NOTICE OF DATA INACCURACY

INSPECTION REPORT

Electrical Corporation:	Southern California Edison Company
Report Number:	PAD_SCE_KSF_20260113_1111
Date of Inspection:	January 13, 2026
City and/or County of Inspection:	Oak View, Ventura County
Inspector:	Keyshawn Ford
WMP Year Inspected:	2025
Quarterly Data Report (QDR) Referenced:	Quarter 3 (Q3)
Inspection Selection:	Energy Safety viewed the contents of the Q3 QDR and performed an analysis that resulted in the selection of the WMP initiatives and locations referenced in this report.
Relevant WMP Initiative(s):	8.1.2.1.1 - Covered Conductor
Inspection Purpose:	Assess the accuracy of Southern California Edison Company's QDR data, completeness of its work, and performance of WMP requirements.

G1mg1: Overall Structure

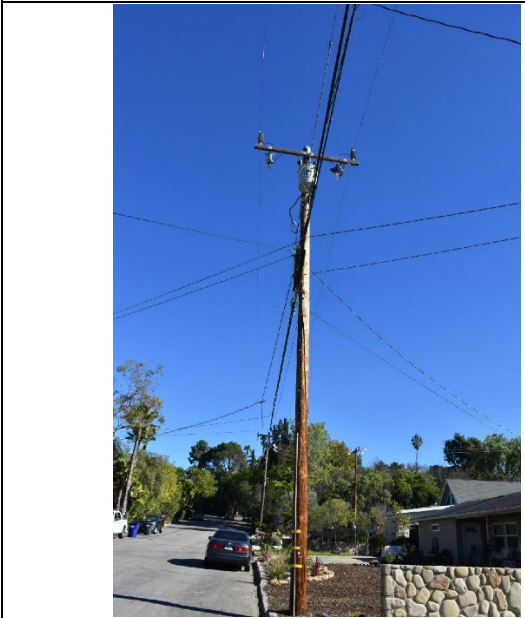
On Pole ID 4630771E, Grid Hardening ID TD2091619-4630771E at 145 Alto Dr, Oak View, CA, 93022, USA, 34.4138108763617, -119.284944142574, the inspector observed that covered conductor was not installed. The inspector's observation is documented in Data Inaccuracy 1 photographs GImg1, GImg2, GImg3, and GImg4, which are attached to this report as Exhibit A.

1. Southern California Edison Company reported that WMP initiative 8.1.2.1.1 - Covered Conductor installation was completed at the inspection location.
2. Covered conductor was not installed; bare conductor was observed.

Within 30 days from the issuance date of this NODI, SCE should provide a response advising Energy Safety of corrective actions taken or planned to remedy the identified data inaccuracy.
